SERVICE BULLETIN

APPLICABILITY: 2019-20MY Forester
2020MY Outback
2019-20MY Ascent

NUMBER: 12-300-20R

SUBJECT: Power Rear Gate (PRG) Switch Trim- Design Change

Trim Cover

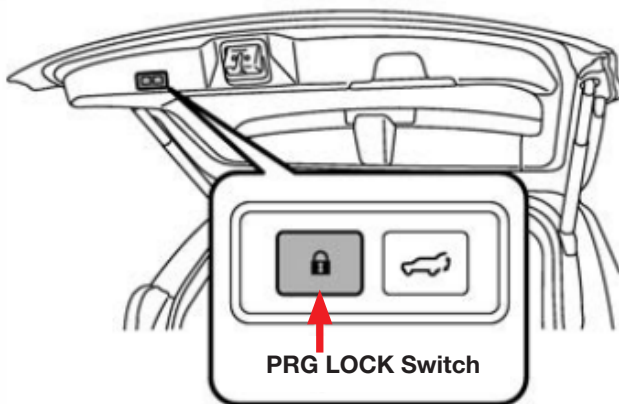
This bulletin announces design changes made to the trim cover for the rear gate PRG control switches located on the bottom of the rear gate inner trim panel as shown below. In some cases, if the buttons are pressed in a certain way, they may become stuck below the surface of the switch cover and not function properly. Changes were made to enhance the rigidity of the part along with increasing the thickness of the locking tabs.

Here, the **LOCK** button is shown stuck below the surface of the switch trim cover.

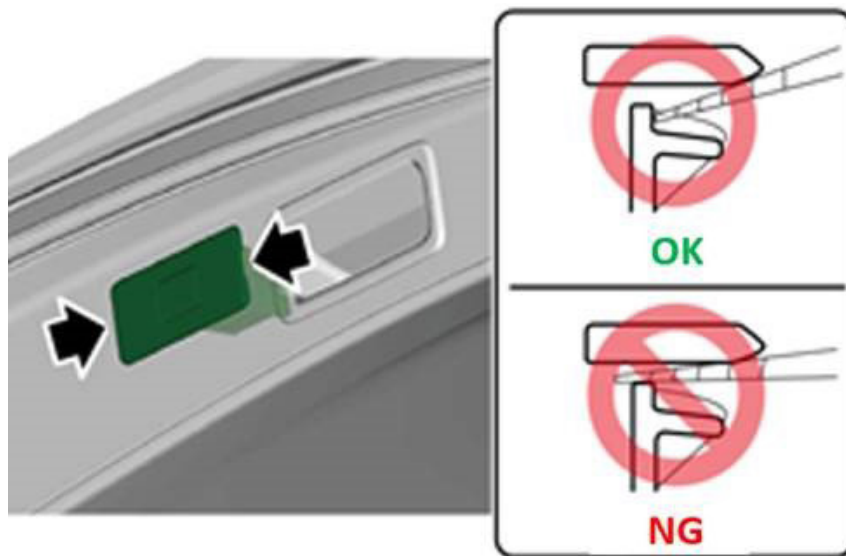
Due to the added rigidity of the new part, it may be more difficult to remove. To avoid damaging the rear gate trim panel, use a plastic trim tool to CAREFULLY depress the lock tabs as shown below.
